**RESPONSES TO COMMENTS
DRAFT INITIAL STUDY / MITIGATED NEGATIVE DECLARATION**

**CASCADE CANYON OPEN SPACE PRESERVE
BRIDGES AND TRAIL IMPROVEMENT PROJECT**

October 23, 2023

Figure 30: Conceptual Restoration Plan

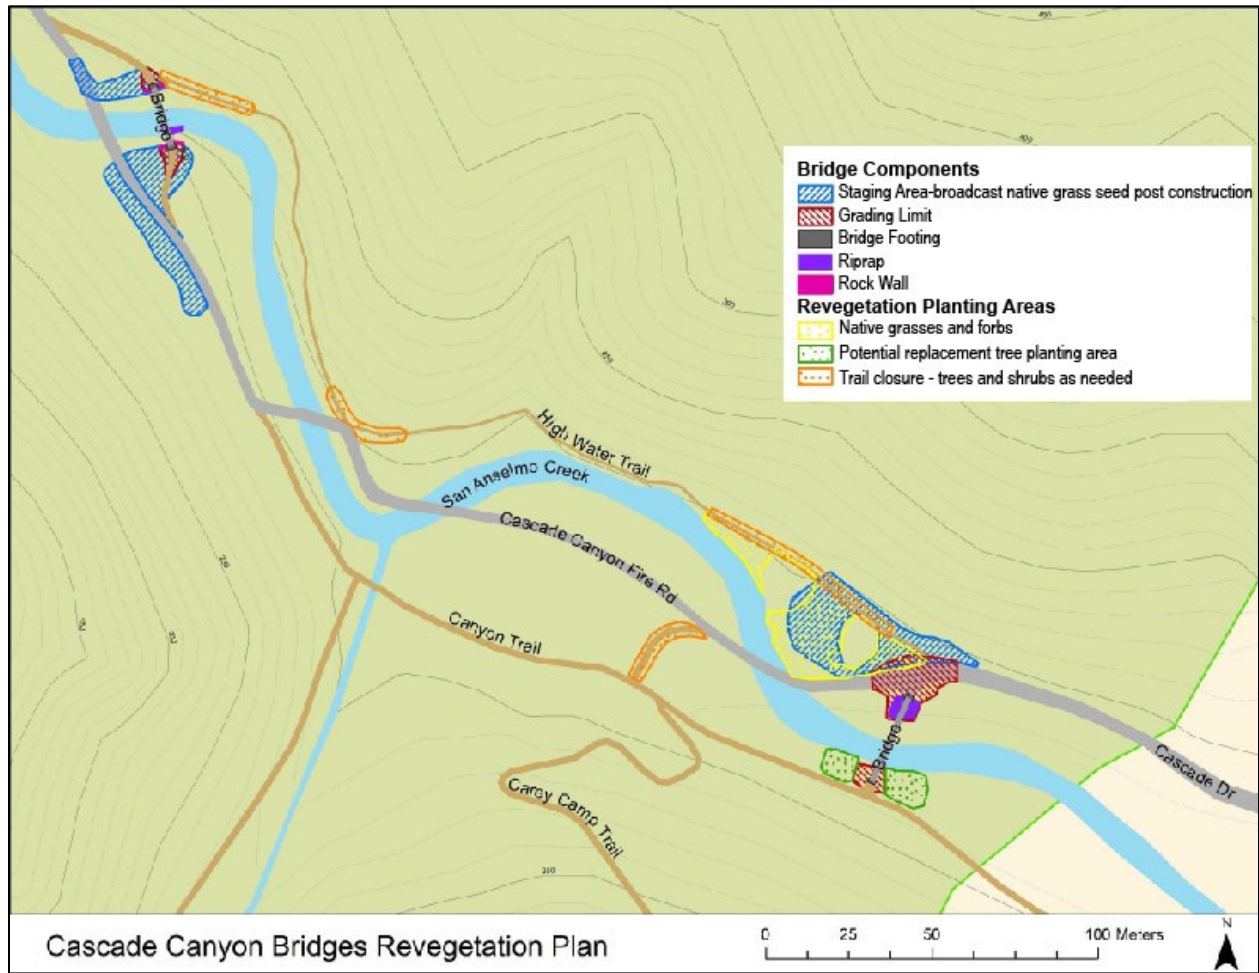
to pre-construction conditions or better. After reviewing comments on the IS/MND and in response to comments from the public meeting requesting the restoration plan be provided in advance of project approval, the MCOSD prepared a Conceptual Revegetation Plan to identify restoration and planting areas. The Conceptual Revegetation Plan was shared with the MCOSD's Environmental Roundtable on August 04, 2021 and was presented to neighbors of the proposed project area on August 26, 2021. Overall, the Conceptual Revegetation Plan was well-received. Requests from the meeting with the neighbors included a revision to Map 2 – Elliott Nature Preserve within Cascade Canyon Open Space Preserve to more clearly delineate the trail system and a revision to Map 29 – Region 2 VBMP Classification to more clearly delineate the vegetation classification zones within Elliott Nature Preserve. These revised graphics are incorporated in the revised IS/MND. There were suggestions to address Douglas fir tree population outside of the project area, to prepare a comprehensive habitat management plan for the entire Elliott's Nature Preserve and Cascade Canyon Open Space Preserve, and to include the decommission of the Cut Trail as part of the restoration. The MCOSD responded that these areas are outside of the project scope and therefore are not included in the Conceptual Restoration Plan. The Conceptual Restoration Plan has now been incorporated into the draft IS/MND and would be submitted to regulatory agencies as part of the regulatory permitting process. The following language has been added to Mitigation Measure BIO-5: Creek and Riparian Habitat Restoration Plan:

The Conceptual Revegetation Plan shows the staging areas with a blue hatch marking. The staging areas would be temporarily impacted by construction activities. In these areas, native grass seed would be broadcasted after project implementation is complete, timed to coincide with the first major rain event of the season. The eastern staging area is mostly contained with the meadow restoration area and would benefit

from additional plantings. These meadow restoration areas are bounded by Cascade Canyon Fire Road, San Anselmo Creek, and the High Water Trail and total approximately 9,500 square feet of currently degraded grassland with a high percentage of weed cover. The meadow would be restored to native grassland which will involve decompaction of the soil, broadcast seeding of native grasses, and planting of container-grown native grasses and forbs, as well as ongoing weed control efforts. Potential native tree planting areas are shown with a green hatch marking and potential areas for additional native trees and shrubs are shown with an orange hatch marking, along the High Water Trail and the connector trail from Cascade Canyon Fire Road to Canyon Trail which are proposed for decommissioning. Shrubs planted on the decommissioned trails would obscure the former trail and encourage visitors to use designated trails. The areas directly adjacent to the west side of Bridge 1 are identified as potential replacement tree planting areas to allow the replacement trees to be planted in the vicinity of the 8-inch DBH madrone that would be removed. Most container plants used for revegetation would be grown at the Marin County Parks nursery from locally collected seed. Approximately 2,500 container plants would be used for initial implementation. Plants would be planted in the winter to early spring following implementation of the proposed project, after the first significant rain event. Plantings would be watered as needed once rains end in spring and will be monitored for drought stress post-planting. Figure 30: Conceptual Restoration Plan has been added to the revised IS/MND.

EXHIBIT A

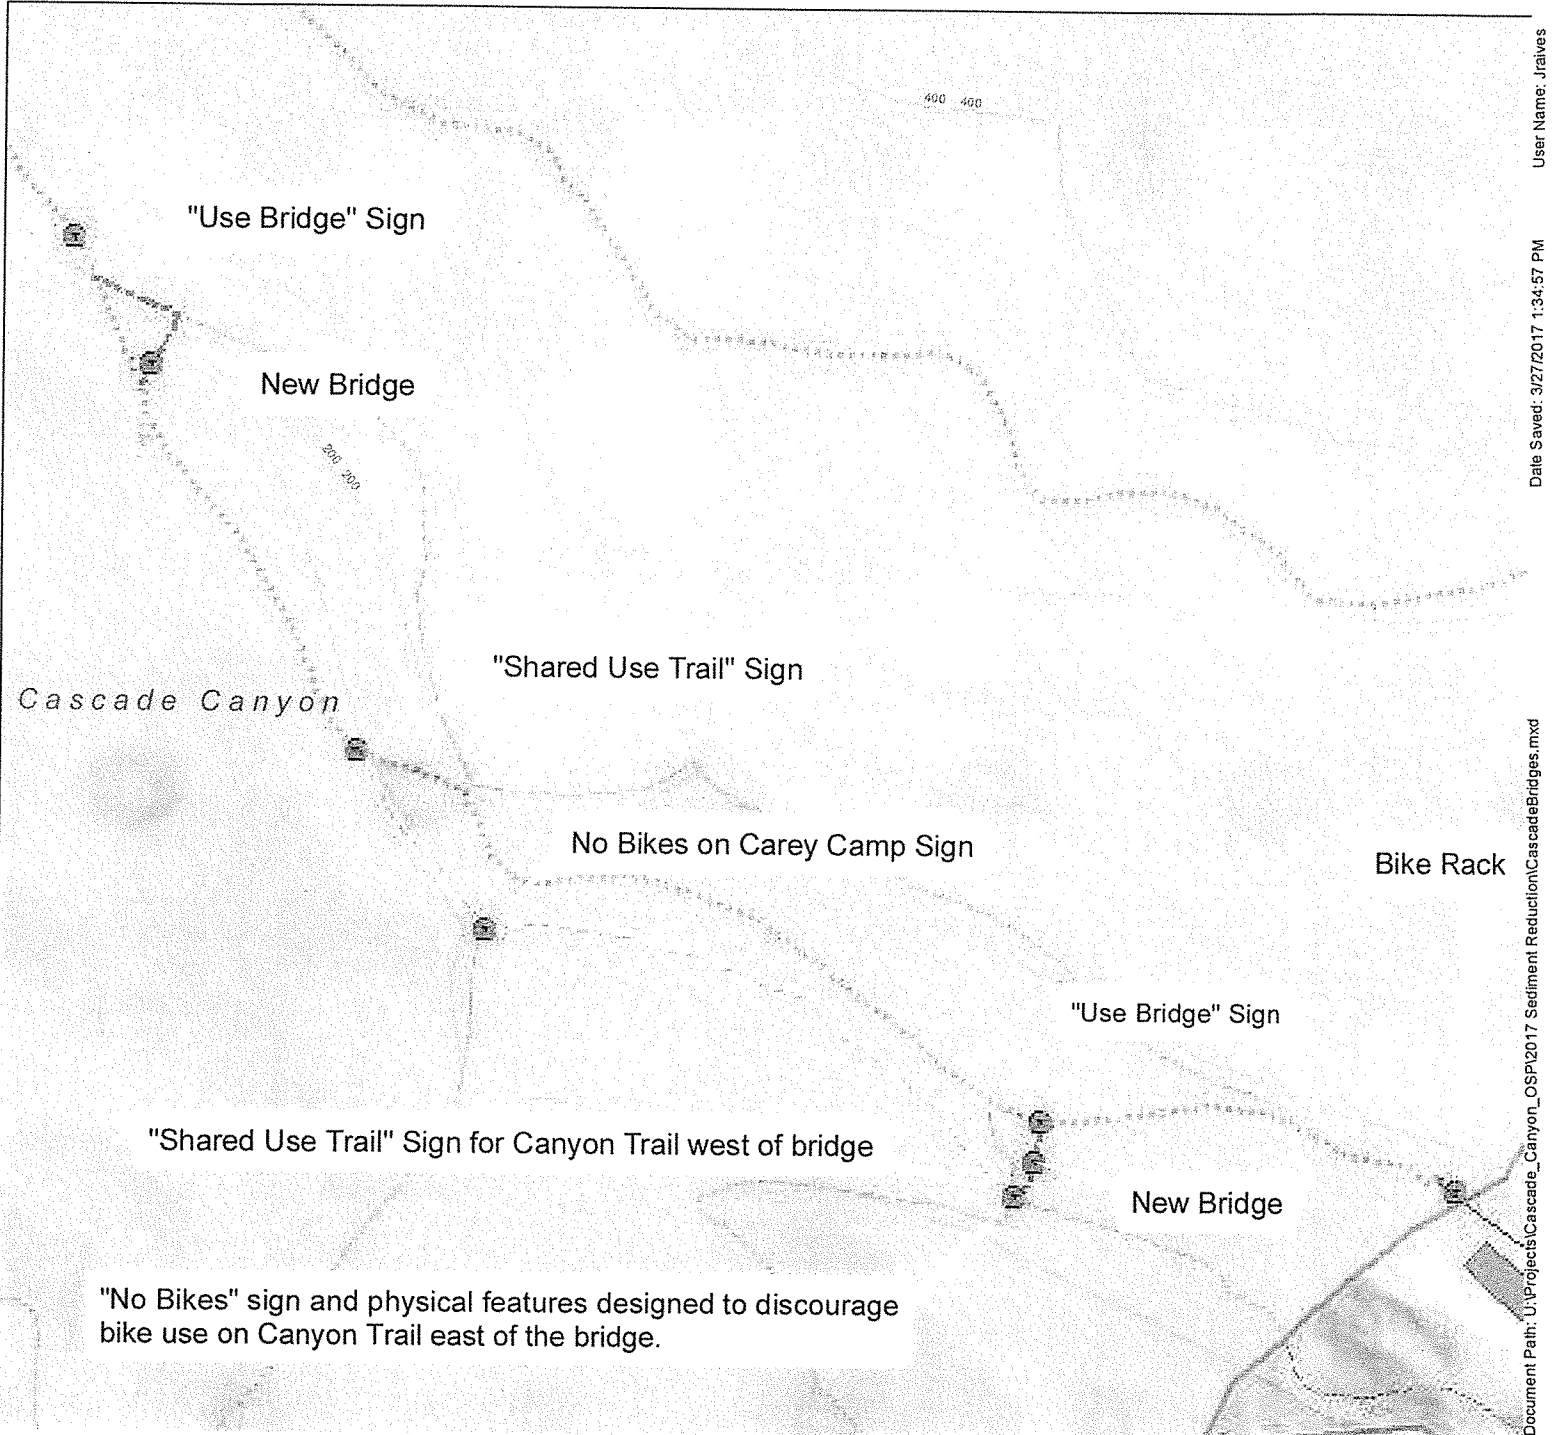
When the Town of Fairfax entered into the Memorandum of Understanding (MOU) with MCOSD, the MCOSD did not advise the Council of environmental impacts which would require mitigation, CEQA compliance, biological reports, or of the IAP compliance designation. Figure 20 does not show the IAP designation.

Exhibit A to the MOU consisted of a map showing where the signs and bike rack would be located, which was included in the IS/MND as Figure 20. The project design implements the requirements included in the MOU. Figure 20 in the IS/MND does not show the trails that would be compliant with the MCOSD's Inclusive Access Plan (IAP), which was finalized in July 2016, because project design had not been completed when the MOU was signed. All elements of the proposed project would be compliant with the MCOSD's IAP.
